**CTF *Structured Invitation to Outside Experts* in relation to current modeling results and how the Draft Supplemental Environmental Impact Statement (DSEIS) may deal with them**

**Raymond C. Vaughan, Ph.D., P.G.**

**September 28, 2022**

**Adapted from 2010 EIS, Figure E-6 Geologic Cross-section through the South Plateau**

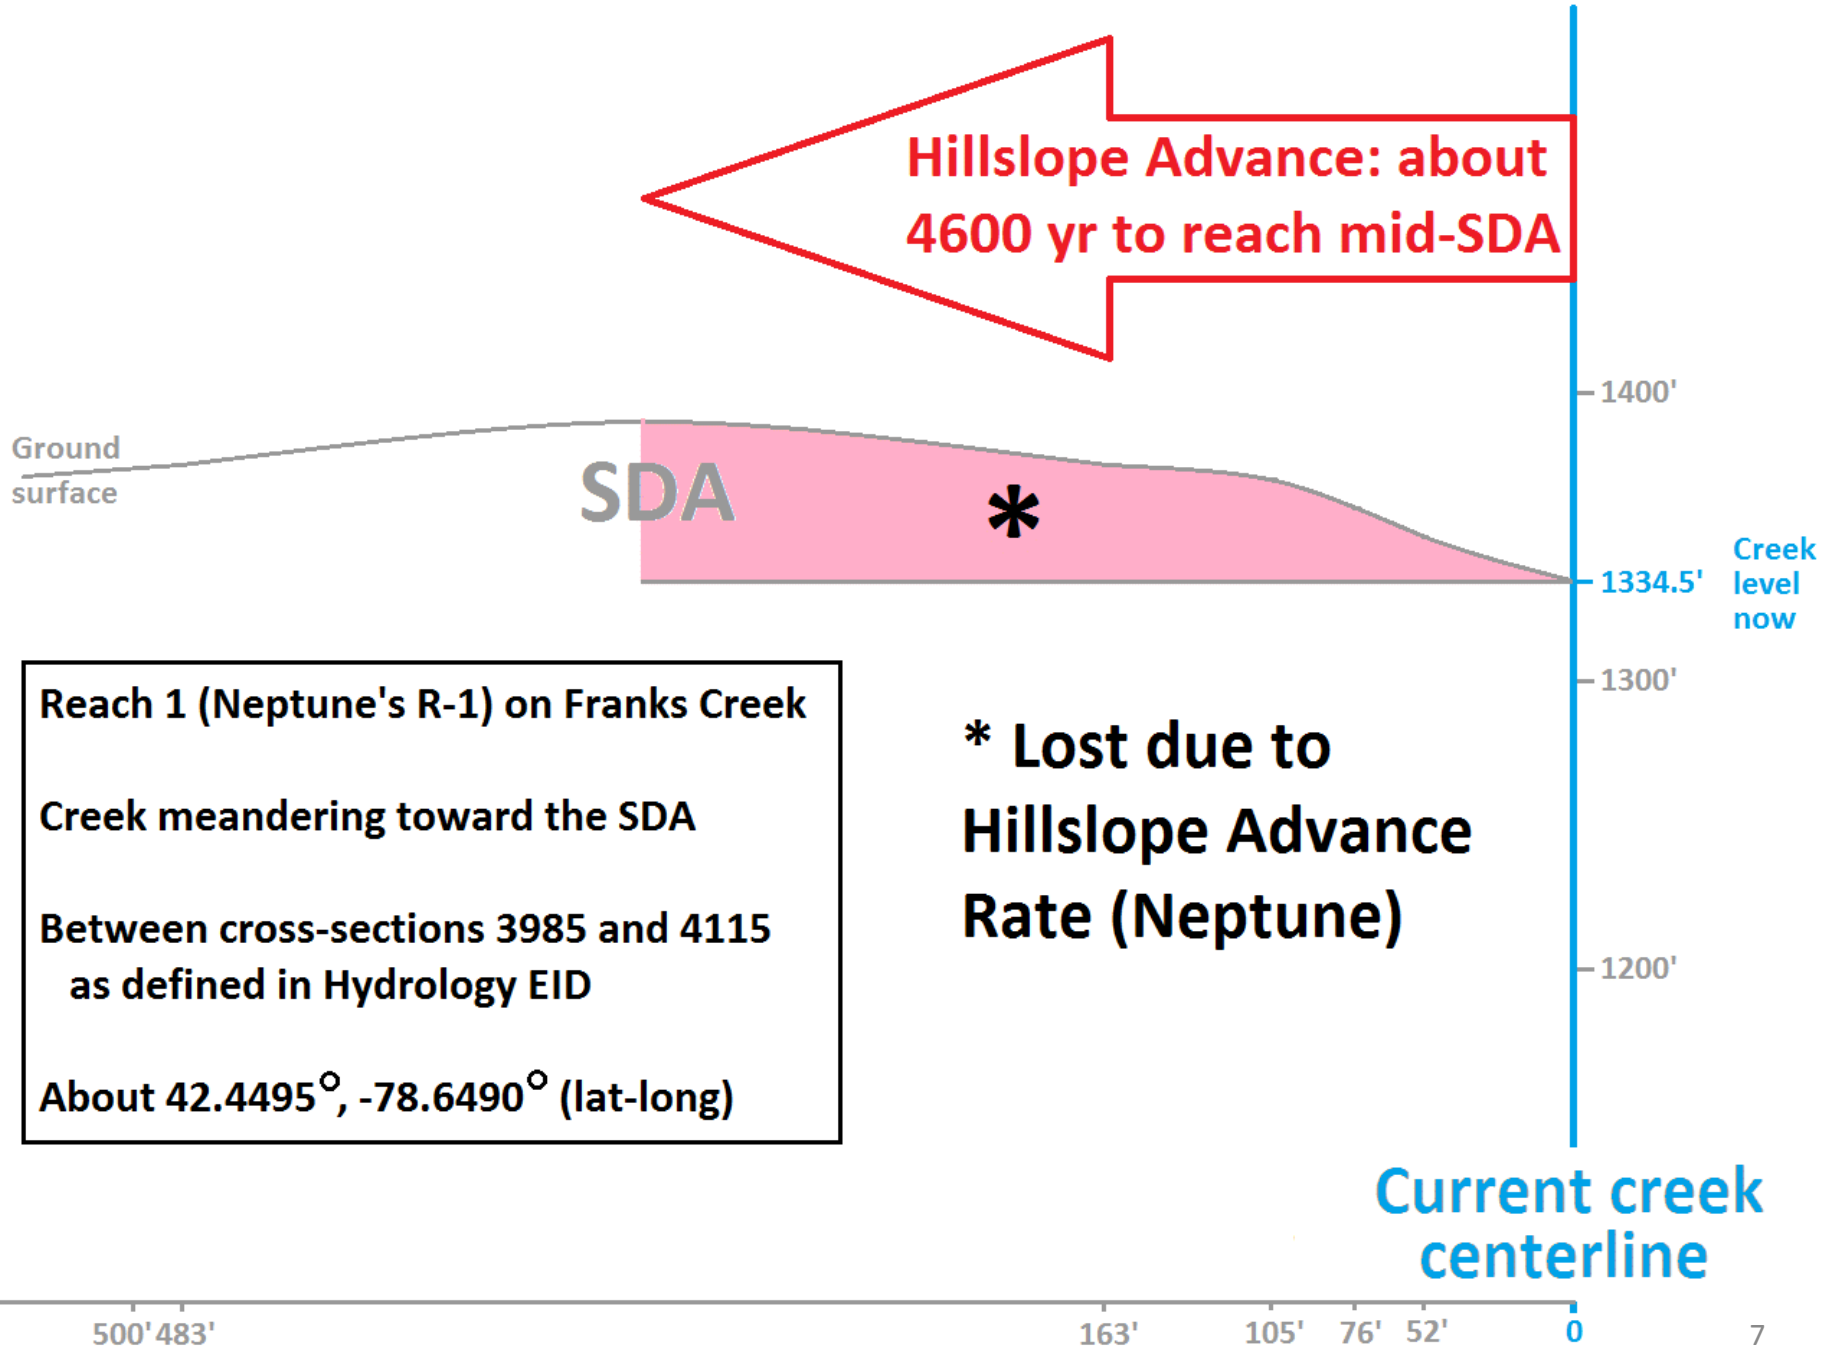
Vertical red bar shows 50 foot (15 m) Franks Creek downcutting alongside SDA at about  $42.4495^{\circ}$ ,  $-78.6490^{\circ}$ , more or less as predicted by EWG erosion modeling by Tucker & Doty.

Diagonal red lines show  $21^{\circ}$  stable slope angle, adjusted here to match vertical exaggeration.

**Landscape Evolution Model, despite its  
issues, shows about 50 feet downcutting**

Downcut  
50 feet

# WITH CLIMATE CHANGE

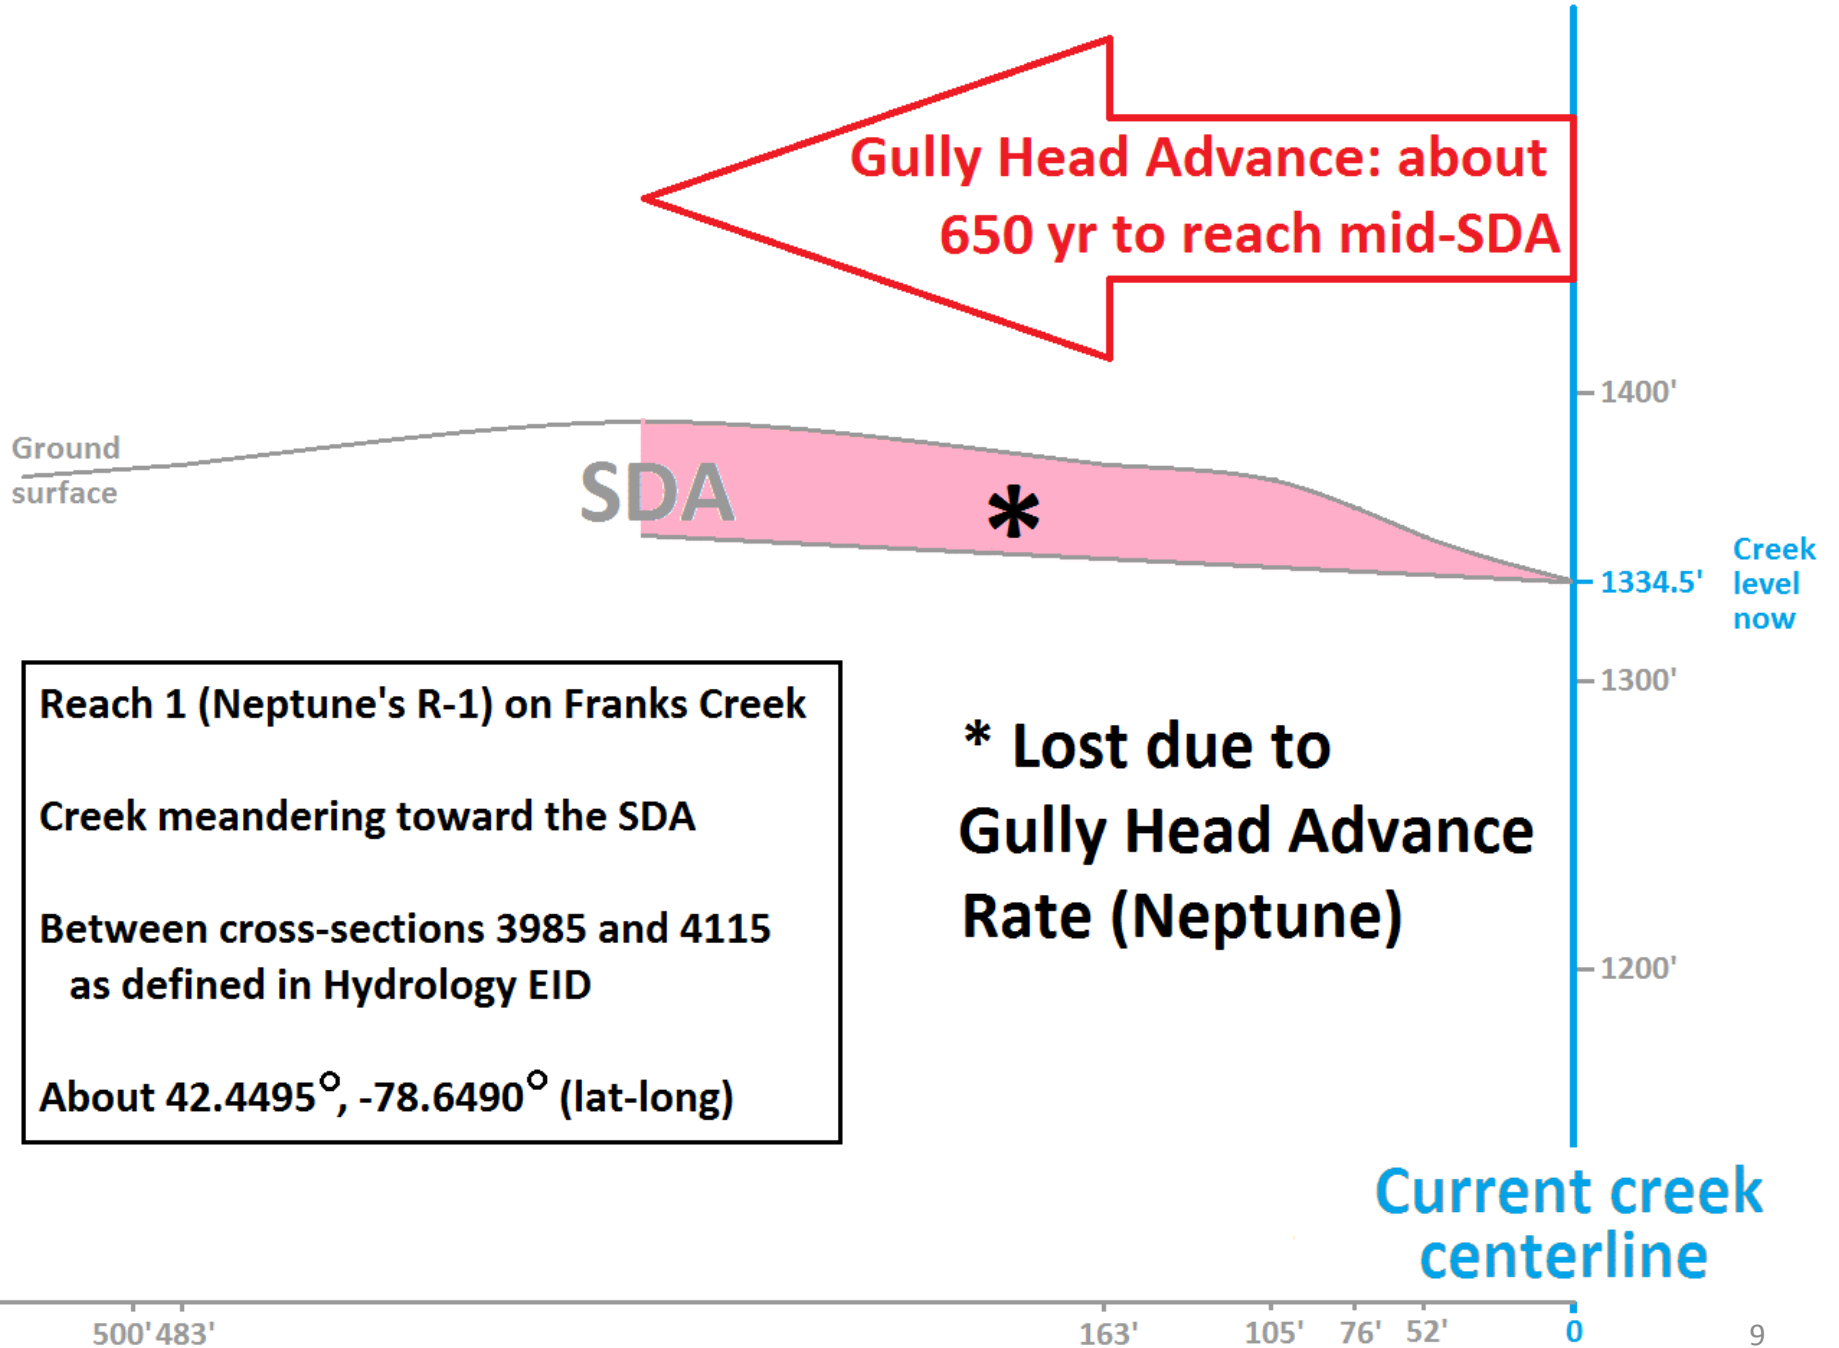
Hillslope Advance: about  
3000 yr to reach mid-SDA

\* Lost due to  
Hillslope Advance  
Rate (Neptune)

**Neptune's work shows SDA being breached in less than 1000 years by Gully Head Advance and less than 10,000 years by Hillslope Advance.**
